MAY 21, 2018

ADDENDUM NO. 2
TO THE CONTRACT DOCUMENTS

SYRACUSE HANCOCK INTERNATIONAL AIRPORT
REHABILITATION OF DEICING STORAGE FACILITIES

FAA AIP PROJECTS NO. 3-36-0114-XXX-18

G-101

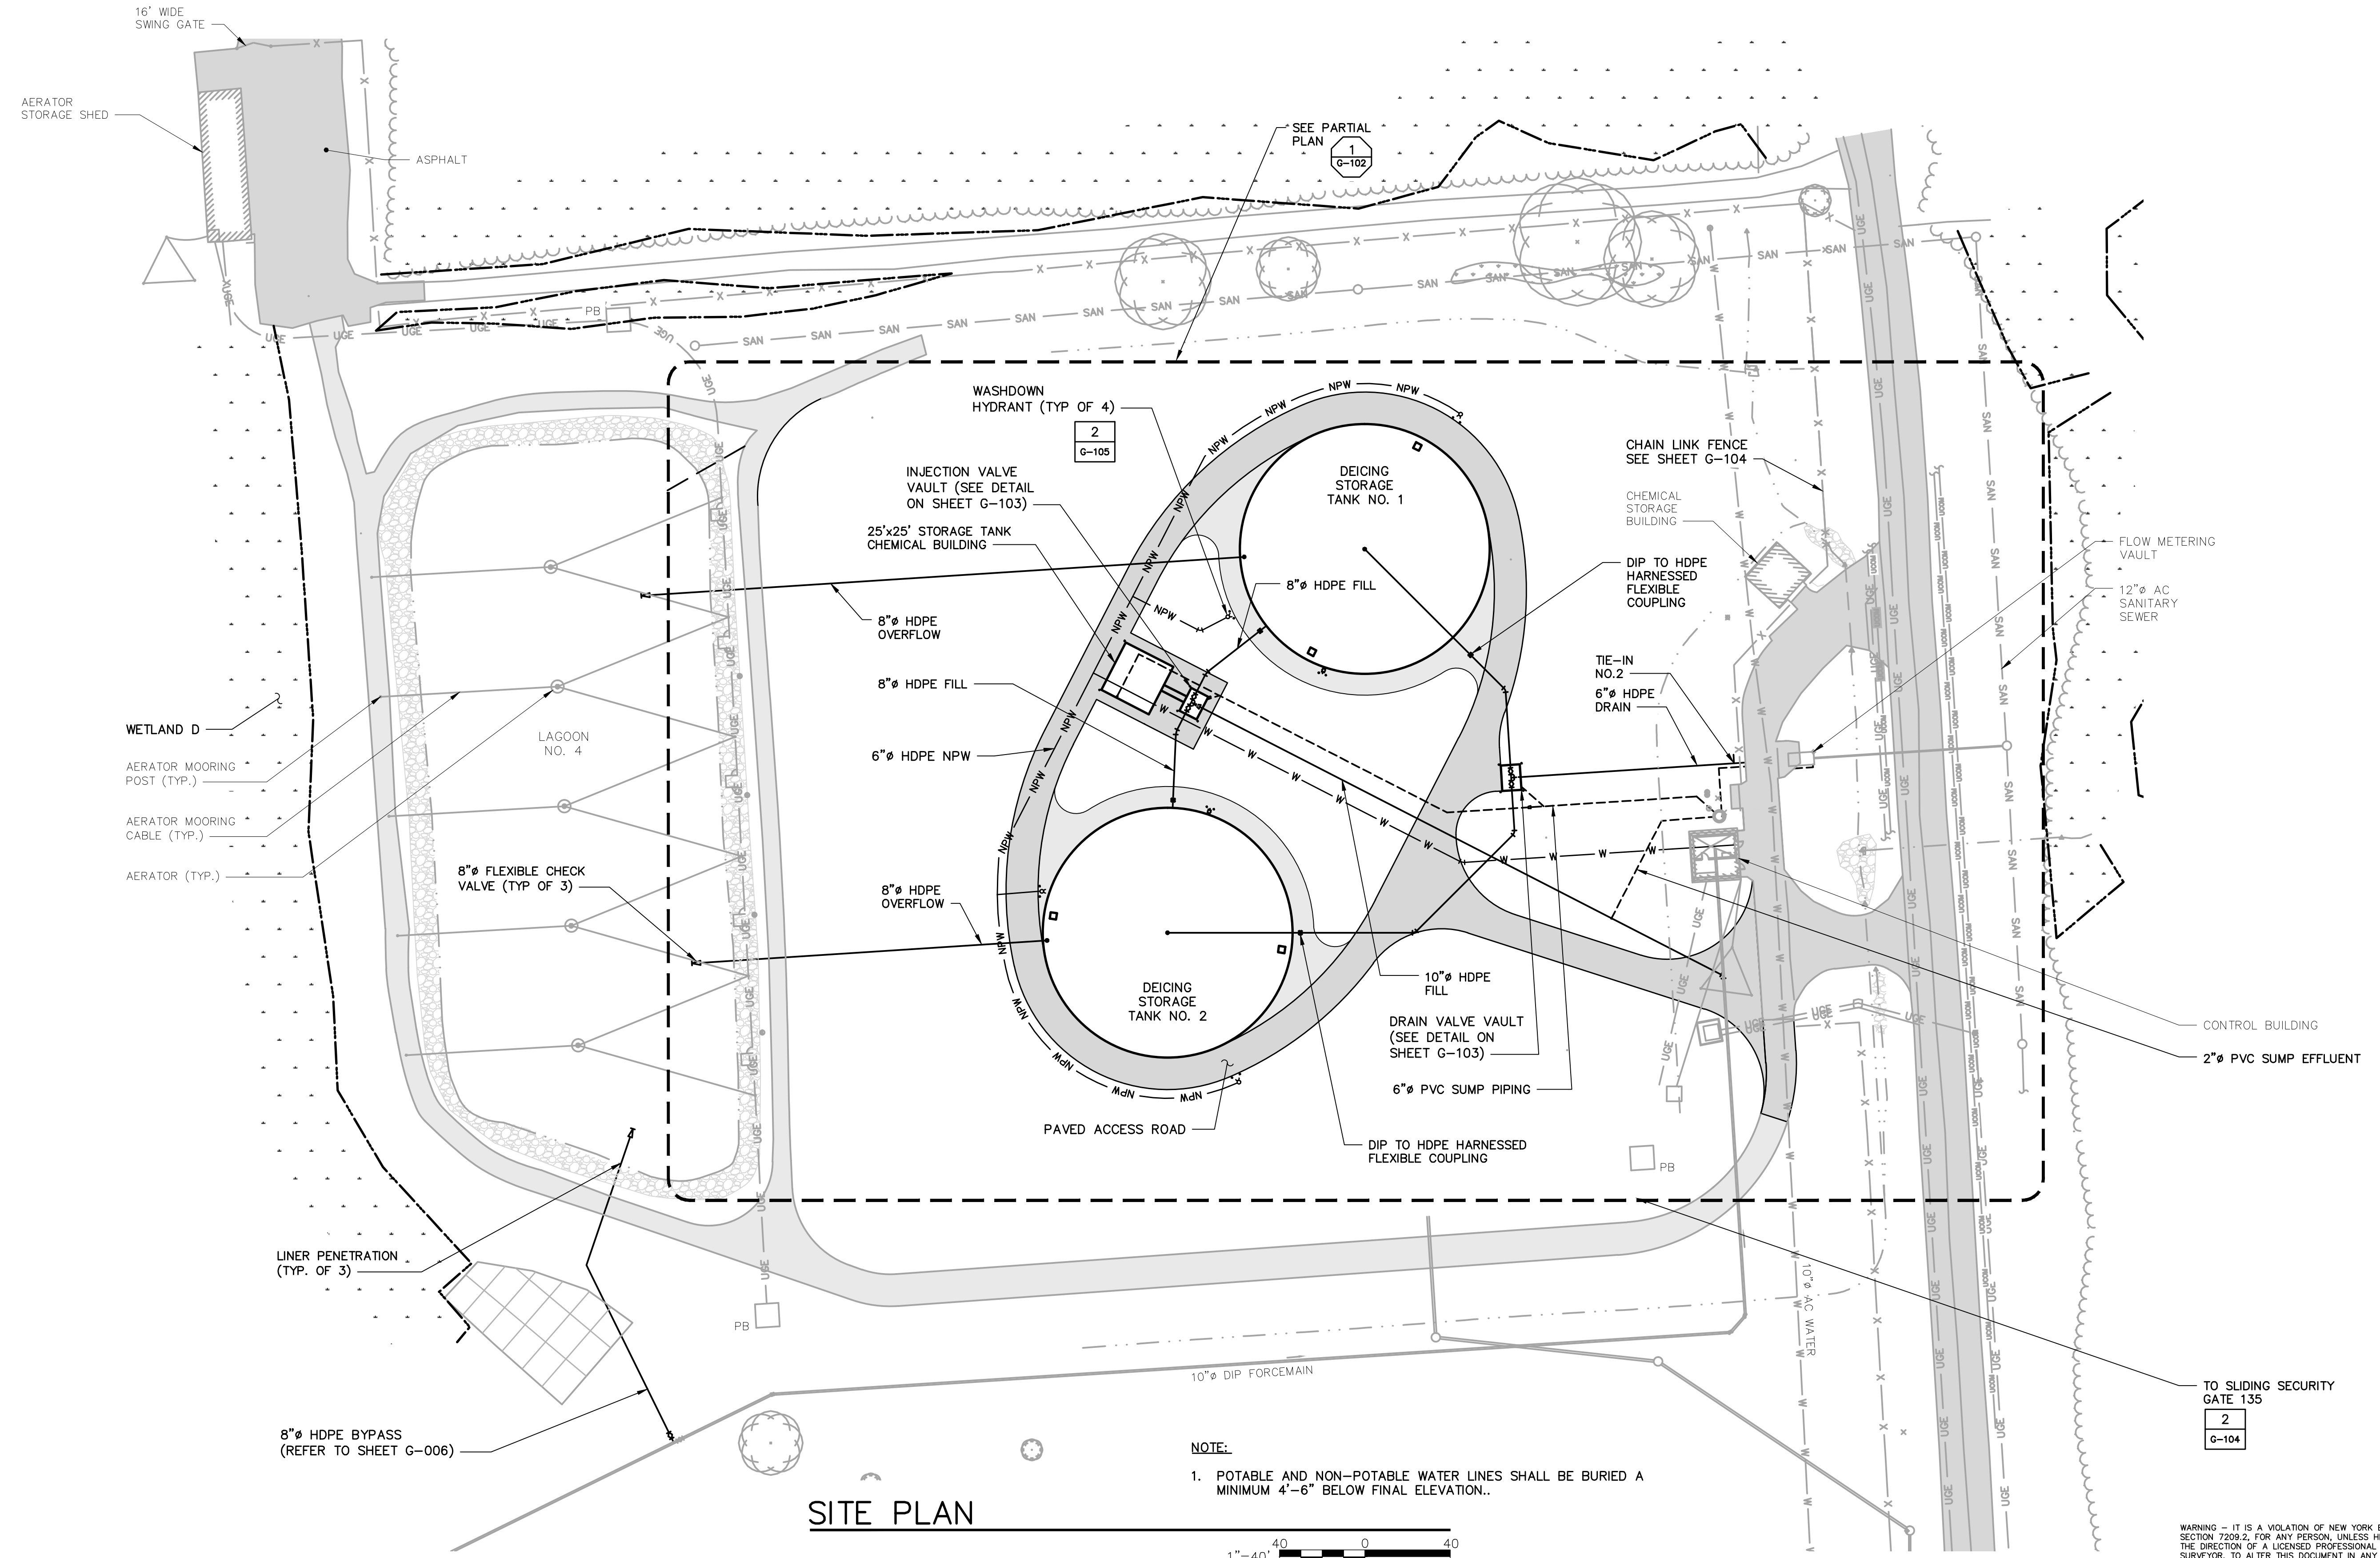
1. Contract Drawing G-100, After Note 1:
 - a. Insert:

“2. THE FOLLOWING REPRESENTS ESTIMATES FOR EARTHWORK: TOTAL GENERAL FILL TO BE EXCAVATED IS +/- 11,500 CY. TOTAL GENERAL FILL TO BE PLACED AND COMPACTED IS +/- 10,000 CY. TOTAL EXCESS FILL IS +/-1,500 CY. CONTRACTOR SHALL MAKE HIS/HER OWN ESTIMATE OF EARTHWORK QTYS BASED ON THE CONTRACT DOCUMENTS”
2. Contract Drawing G-101:
 - a. Delete: Contract Drawing G-101 in its entirety
Insert: Attached Contract Drawing G-101
3. Contract Drawing G-102:
 - a. Delete: Contract Drawing G-102 in its entirety
Insert: Attached Contract Drawing G-102
4. Contract Drawing G-106:
 - a. Insert: Attached Figure 1: “SEWER CLEANOUT AND VENT DETAIL”
